**GEOHYDROLOGY AND GEOCHEMICAL
REPORT and DOCUMENT REVIEW
of the
COTTER/LINCOLN PARK SUPERFUND SITE**

Colorado Citizens Against *ToxicWaste*, Inc.
P.O. Box 964
Cañon City, CO 81215

June 30, 2007

Patterson 2007
Figure 1f

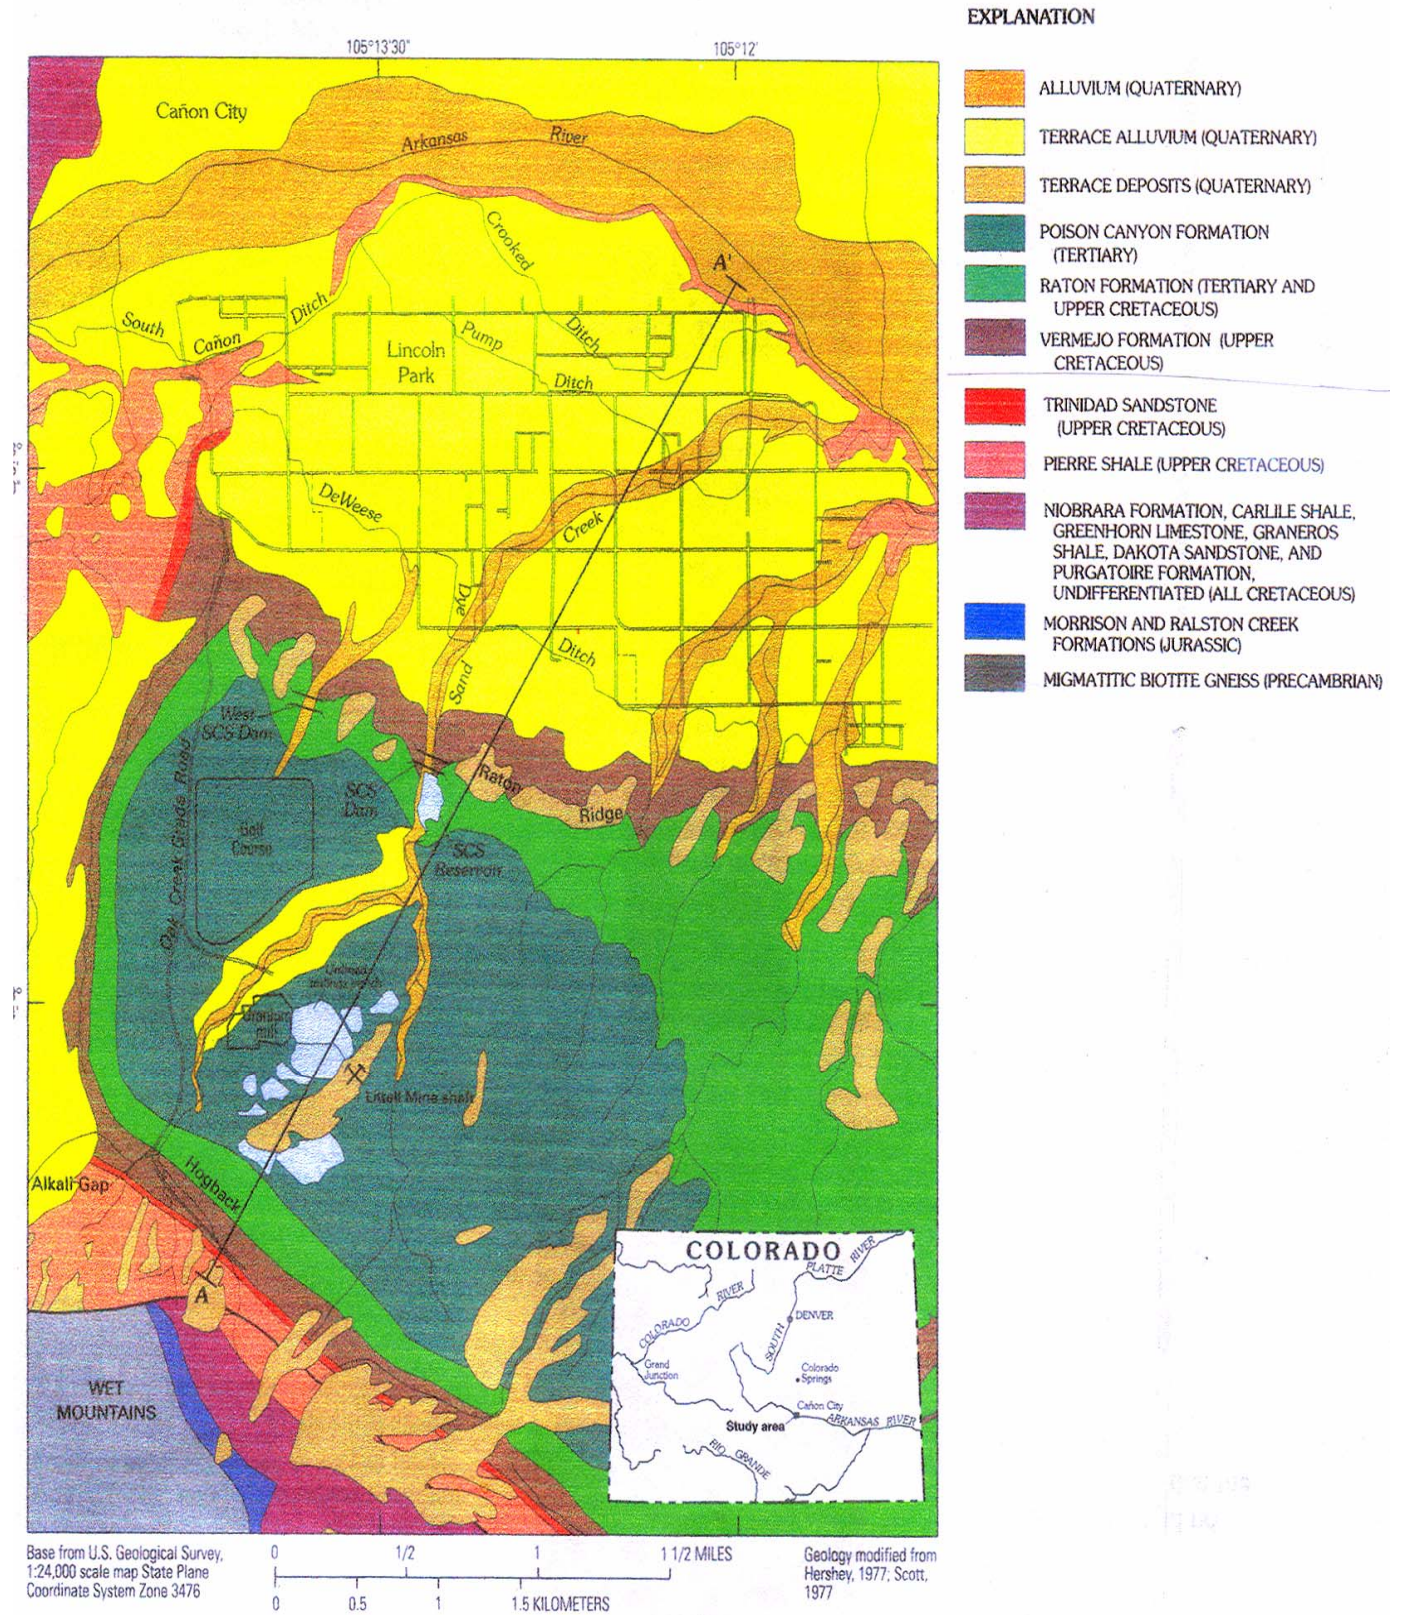
A USGS map (Chafin and Banta, 1999) showing some monitoring wells, subsurface coal mine boundaries and possible migration paths of contamination is also provided (Fig. 1f). Stephens (1993) created an excellent Site Conceptual Model of a cross-section showing the coal bearing Vermejo Fm emerging at the surface in Lincoln Park where Wells 006 and 138 are located (Fig. 2eii). Lehman (1991) provides another cross-section showing the Wolf Park Coal Seam, of which I added the locations of Well 006 and 138 (Fig. 2g).

Patterson 2007
Figure 2b

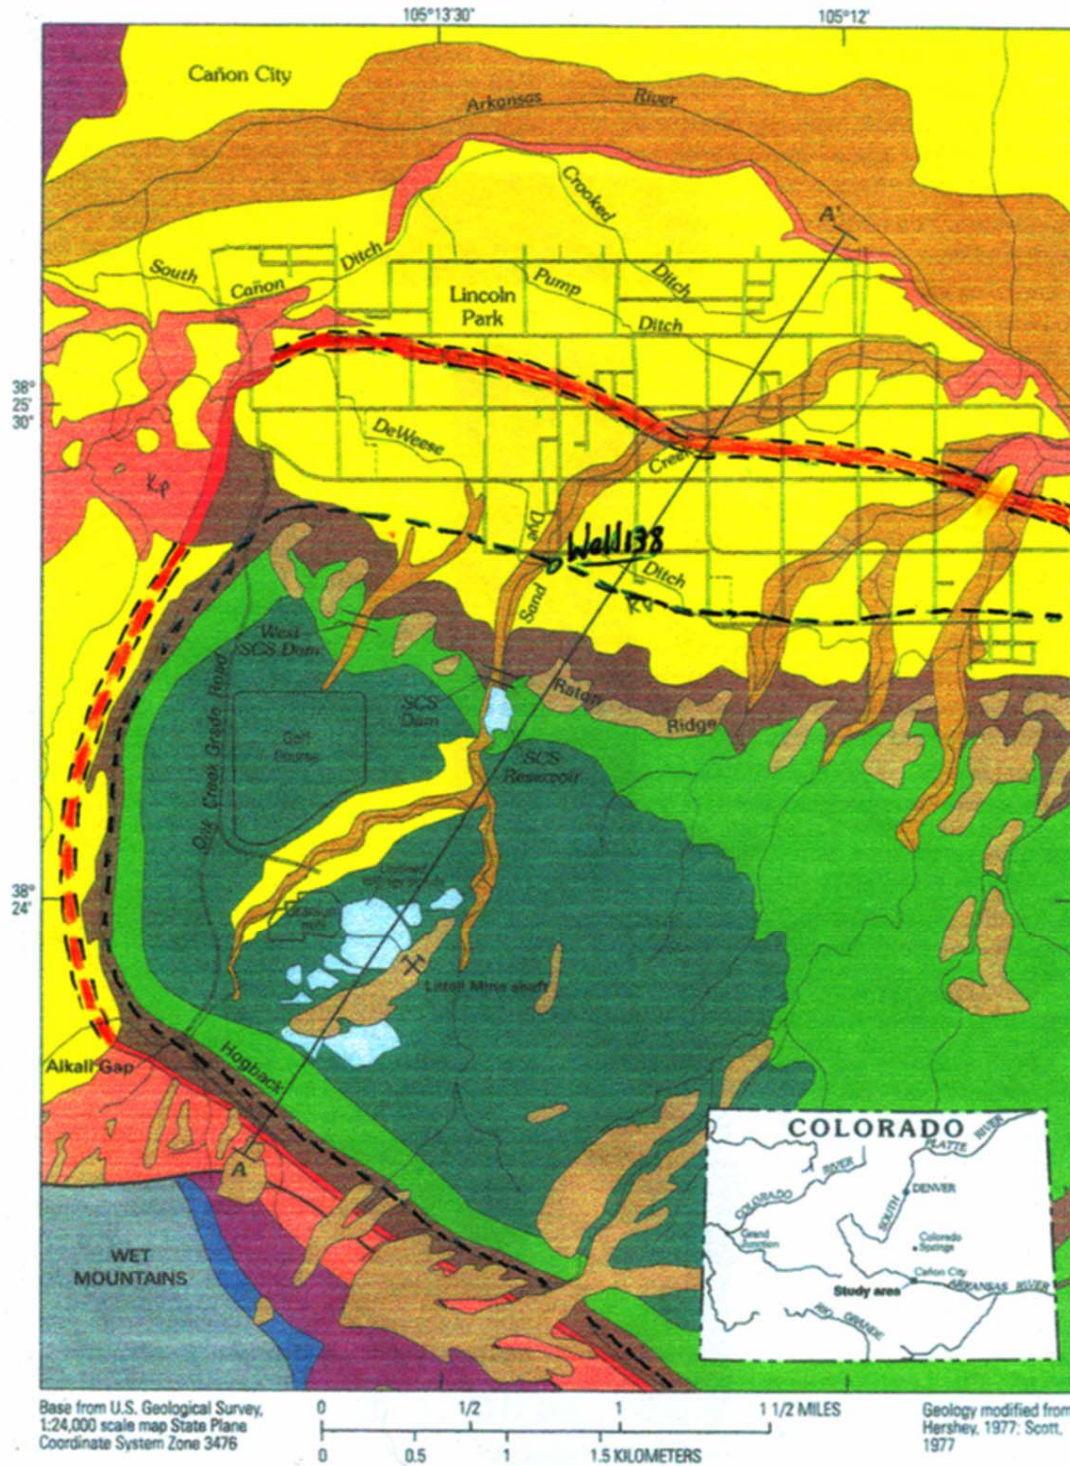
There are at least two lines of evidence supporting the possibility of a “Deep Path.” **First**, test well sampling data provide compelling evidence. A test well of the USGS, Well LP85-1D, in Lincoln Park encountered artesian conditions from a coal seam in the Vermejo Fm (Fig. 2ei). This well was felt to have penetrated the same coal seam as is found in the bottom of Well C138 (now Well 138), which was the "discovery" well of the site, containing high levels of U and Mo (Hearne and Litke, 1987, p. 16). A herd of cattle was rendered ill by water from Well C138 (Runnels, et al, 1977). This coal seam is contacted by Well 006, which carries the highest values of Mo and U in Lincoln Park (Fig. 2e). Chafin and Banta (1999) show a map of the Geology of the study area that clearly shows the Vermejo Fm surfacing from east to west along the southern edge of Lincoln Park (Fig. 2a). I superimposed my estimate of the approximate location of the Wolf Park coal seam and Trinidad Sandstone outcrop/subcrop over that map (Fig. 2b) and over a map from Wahler, 1978, (Fig. 2f).

The plume boundaries farther out in Lincoln Park are fairly accurate, although I see no reason to have an isolated high of U centered around Well 129. This local, isolated high in U could actually be explainable if there was a subsurface (deep path) source for U below Wells 129, 173, 189, etc. The northern E-W extension of the U and Mo plumes seen clearly in Chafin and Banta's (1999) USGS maps (Fig. 3a and 3b) does coincide with the Trinidad Formation, which is actually omitted from their Geology Map (Fig. 2a). Compare their plume contours to my modification of their Geology map (Fig. 2b), and you will see that the E-W extension of the plume coincides with the "red" line indicating the Trinidad Formation emerging in Lincoln Park. Likewise, the southern E-W extension in Chafin and Banta's plume map corresponds to the base of the Vermejo Fm, where the Wolf Park coal seam is located (Fig. 2b) and contacting Wells such as 138 and 006.

Patterson 2007
Figure 2f

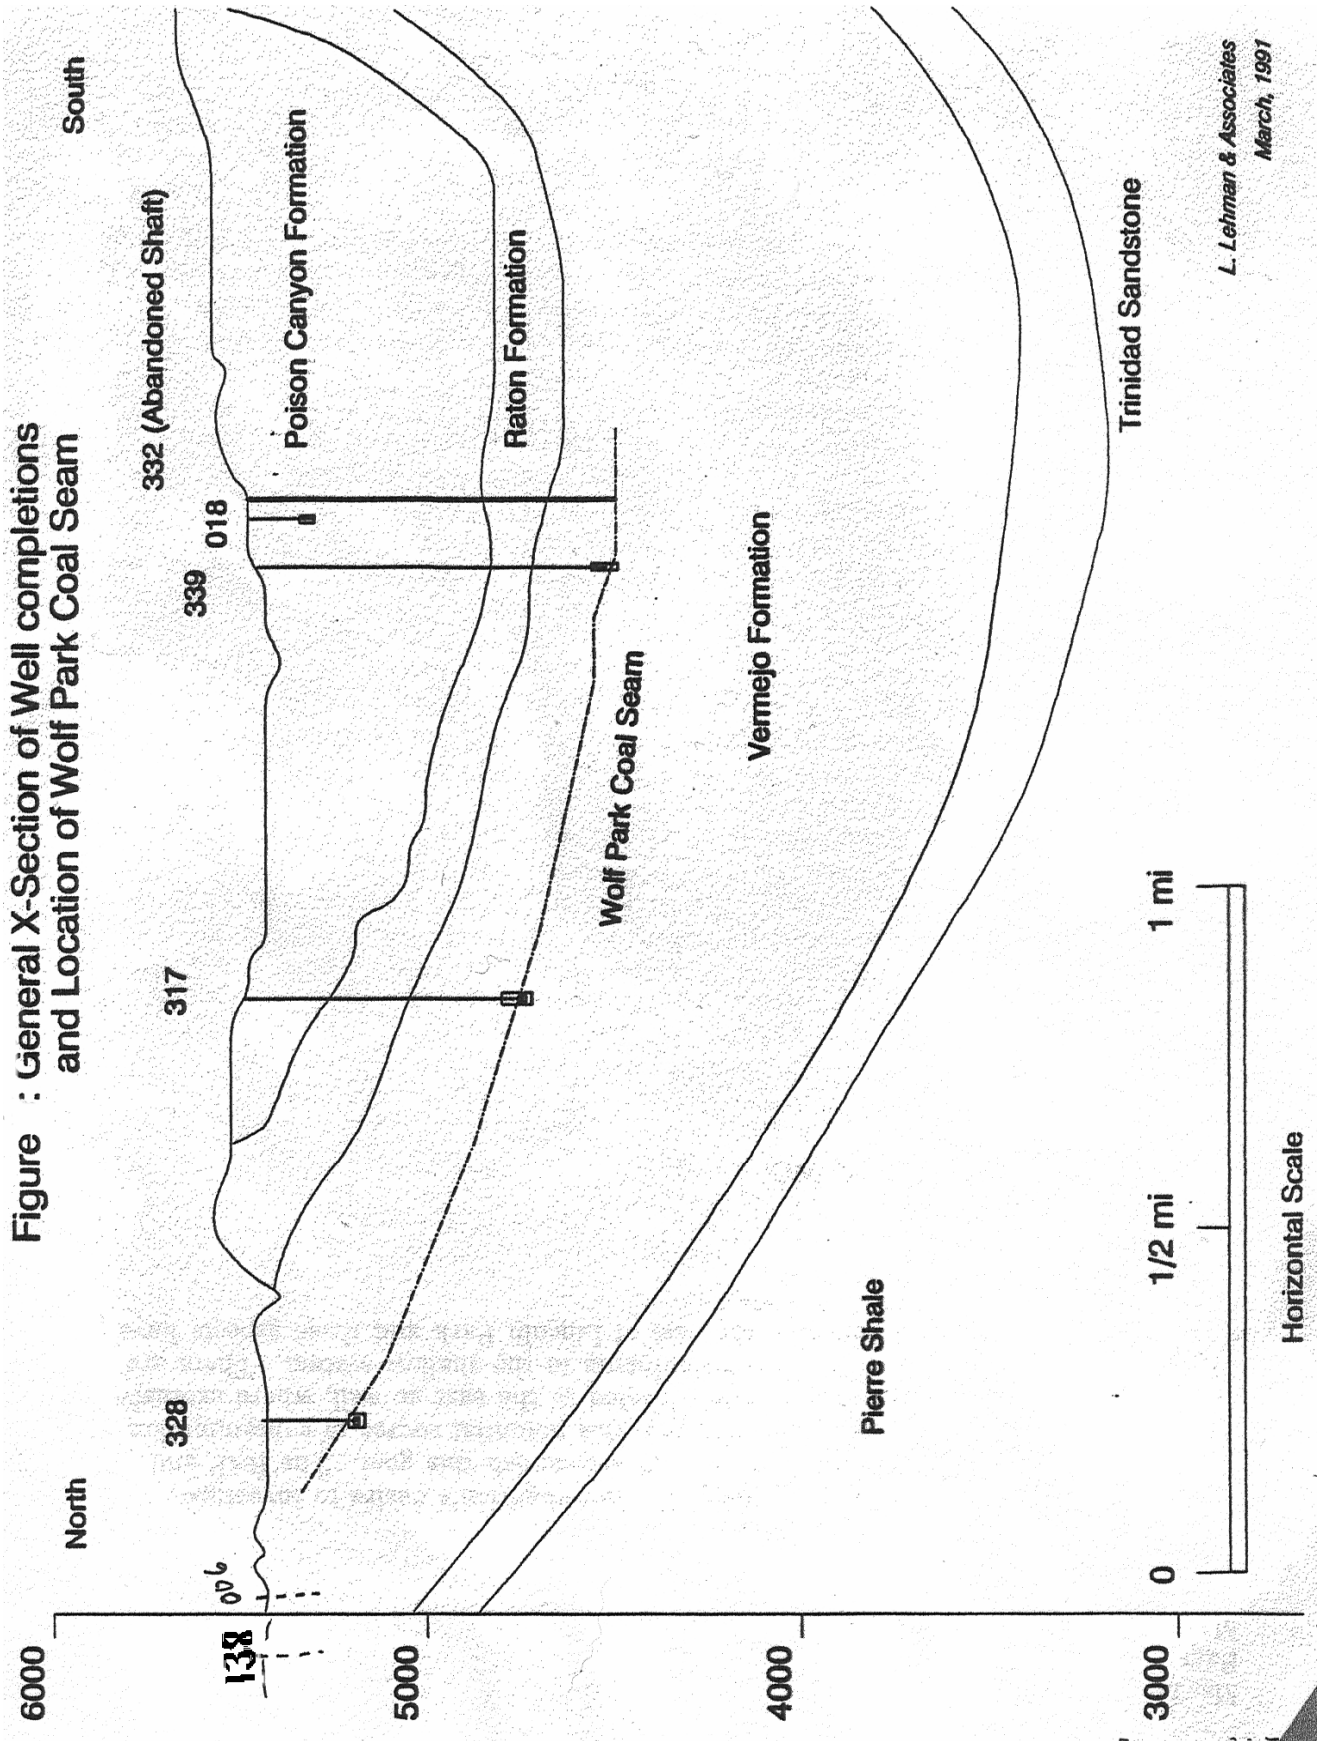
4. Hearn and Litke postulated "industrial activities" or a deep aquifer. I have mapped the formations around the Chandler Syncline and the water coming through Alkali Gap flows over the Trinidad Sandstone and the Vermejo FM before it enters the plant site (Fig 2f). Vermejo-derived water is high in TDS, sulfate, and fluoride.

Cotter (2005), p. 7-26 [Flow lines, impoundment, Little Shaft, and underdrain locations drawn by Patterson 2007] Patterson 2007
Figure 3d

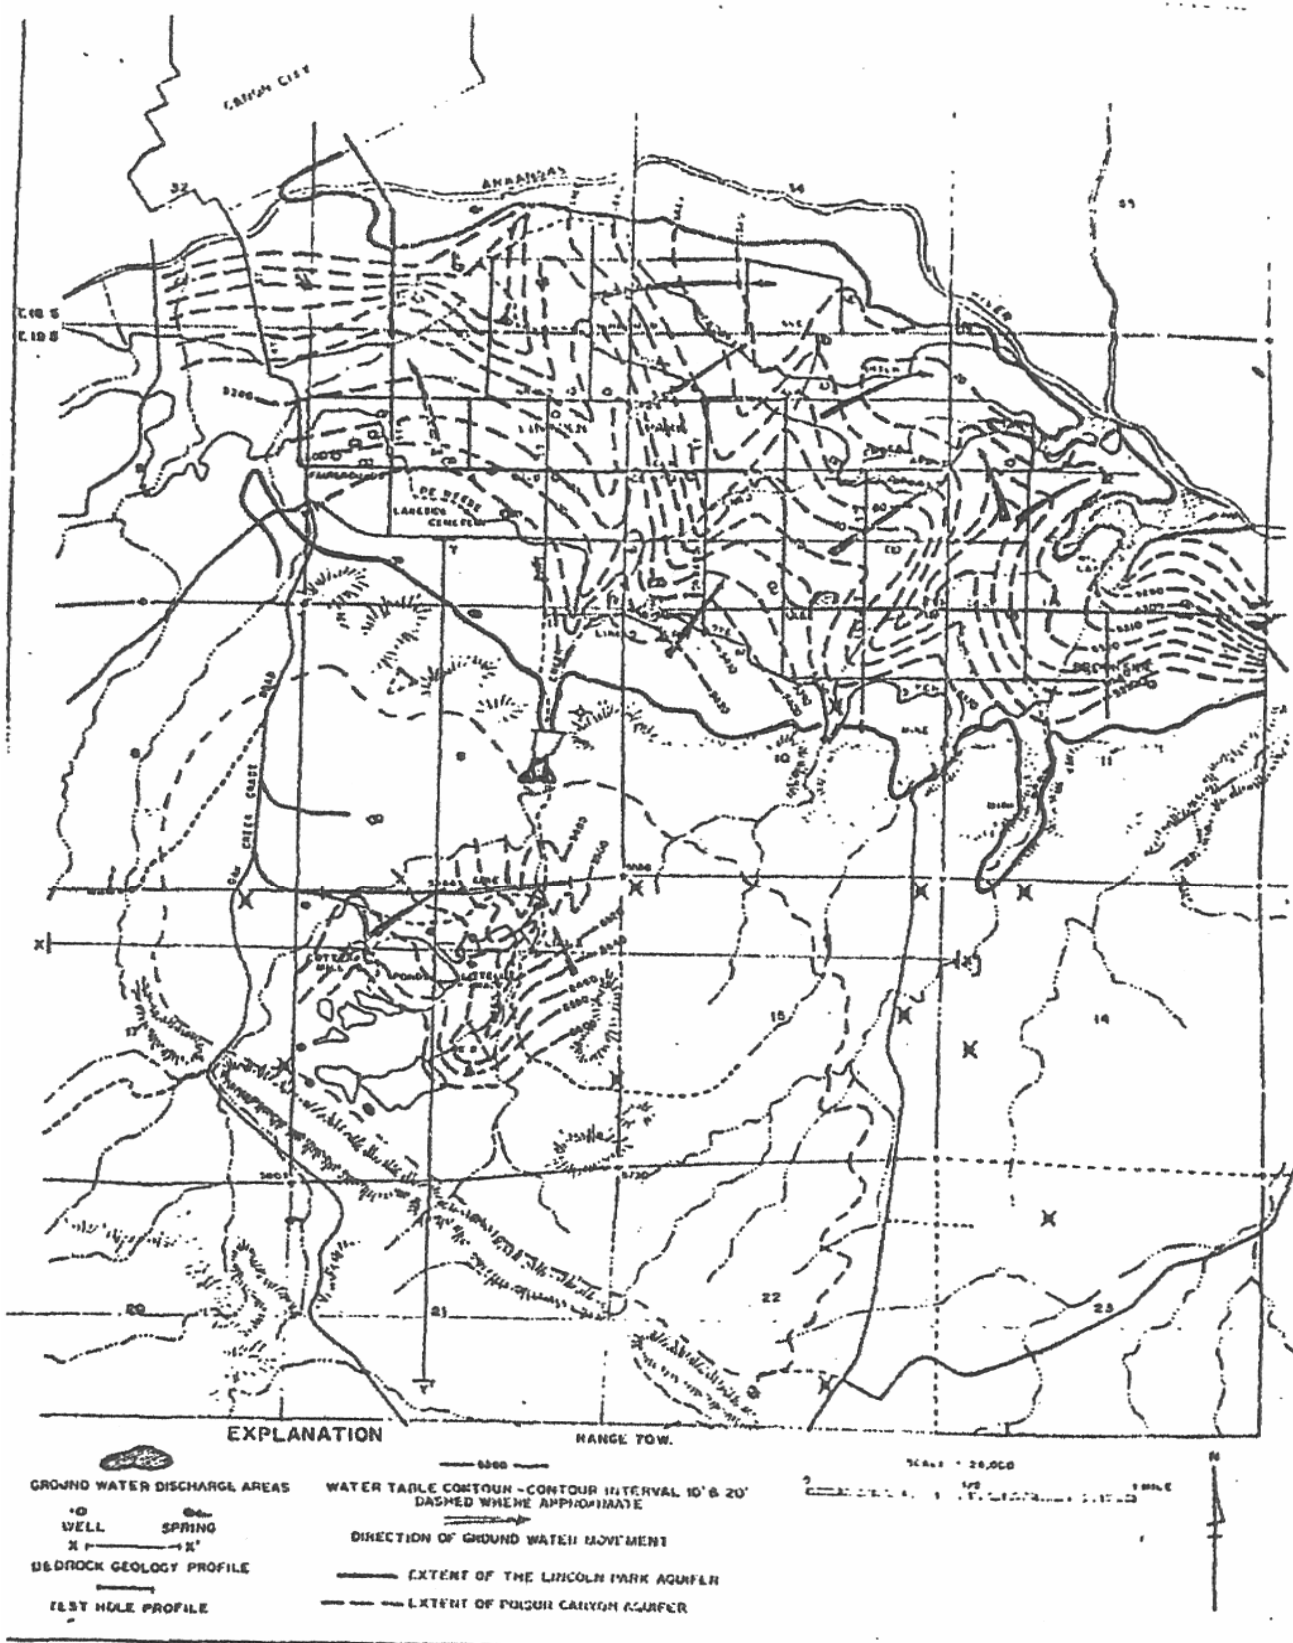
Many of these features I have plotted on a blow-up of the table map (Fig. 3d). They clearly show that well 003 is cross-gradient to the main impoundment, and well 808 is not receiving seepage from the main impoundment, rather from the ground water mound to the NW.

Well 808 is very low in TDS and is a Na-bicarbonate-sulfate type of water. That would indicate to me it is being recharged by water from the ground water "hump" immediately to the northwest, as flow lines would indicate. The origin of this "hump" and the one adjacent to it to the NW is unknown, but it would seem an explanation of its presence is necessary for a fuller understanding of the ground water regime near the pond area (see overhead #2, Flow lines of groundwater contours as shown on fig.7-28).

Patterson 2007
Figure 3e

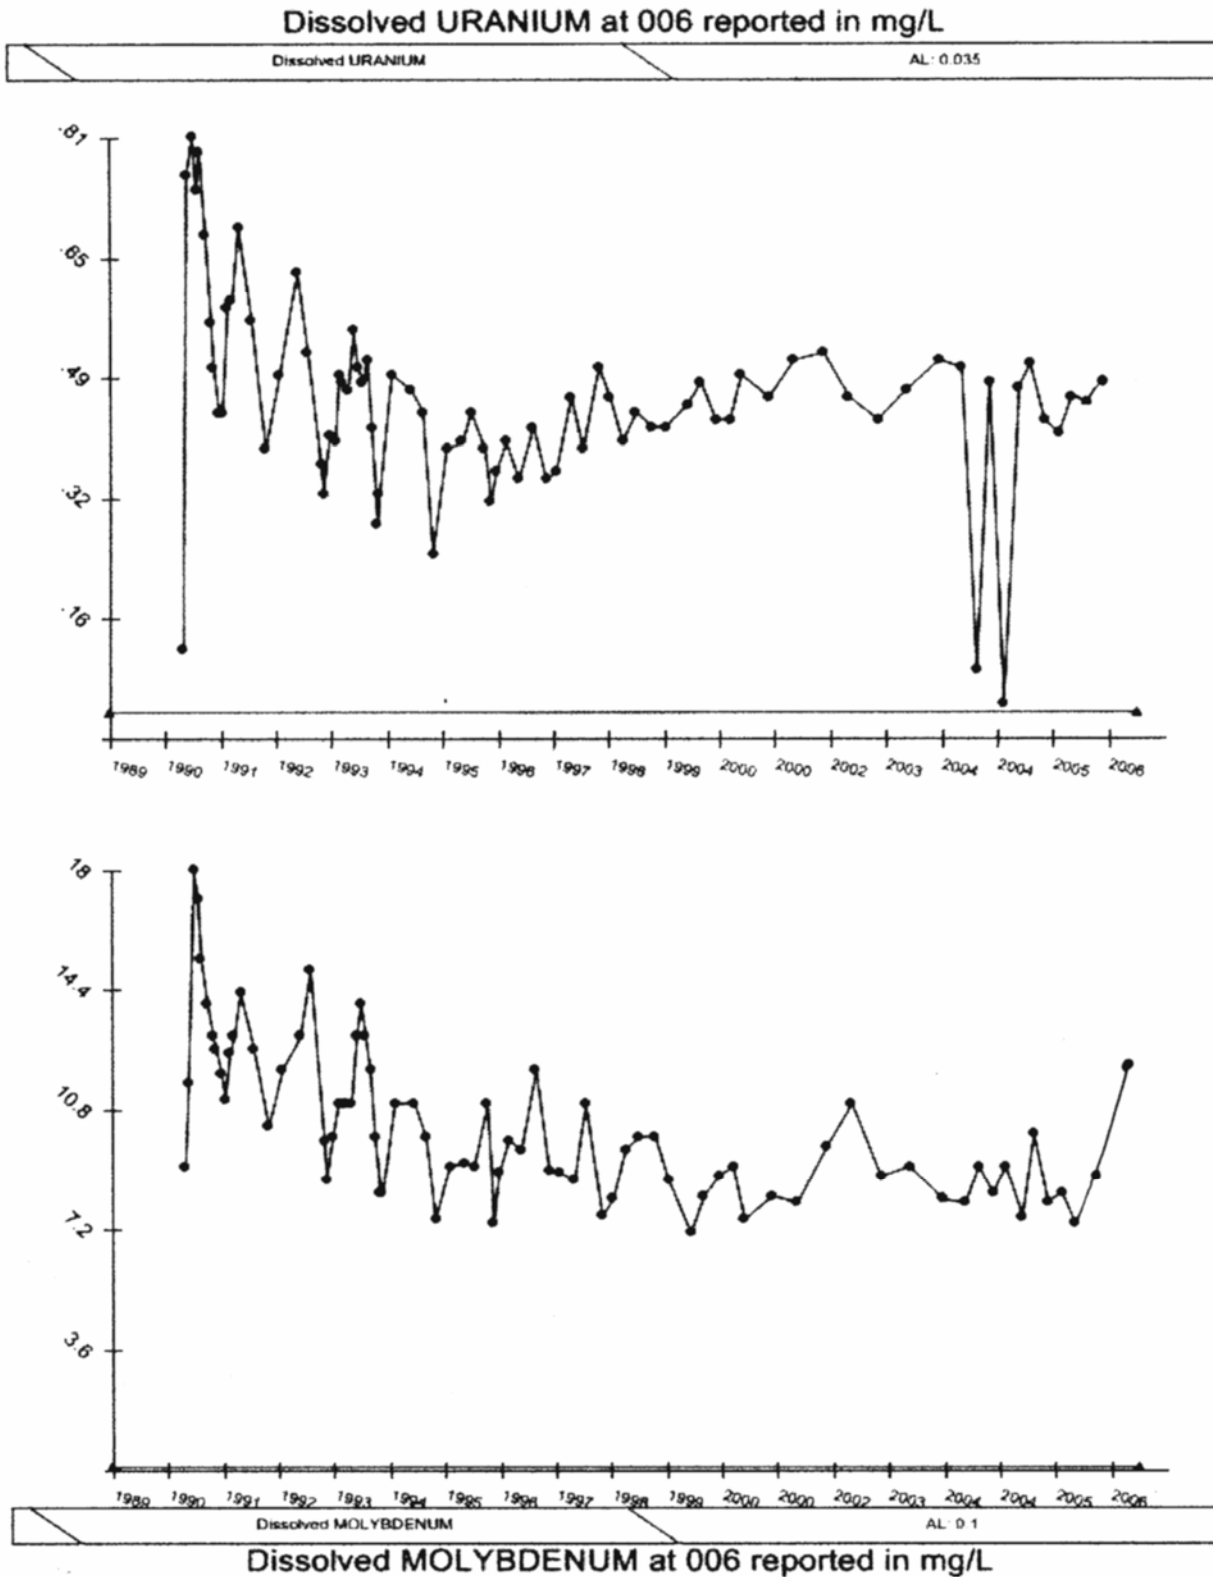
investigation, gave the conclusion that the impoundments were not leaking. However, in the explanatory portion of the text, this conclusion was given equal weight with the possibility of leakage. The choice of one alternative over the other is not warranted by the findings of the study. Further, colors chosen for the subsurface resistivity values differ from colors used at other sites, and give a misleading impression of conditions, at least compared to the examples from other sites shown in the text. Despite this, CDPHE used the study to choose locations for new wells along the edge of the impoundment, where subsequently new Well 379 was found to indicate leakage (Figure 3e). See my special report (**Appendix B, Section 2.0 and 3.0**).
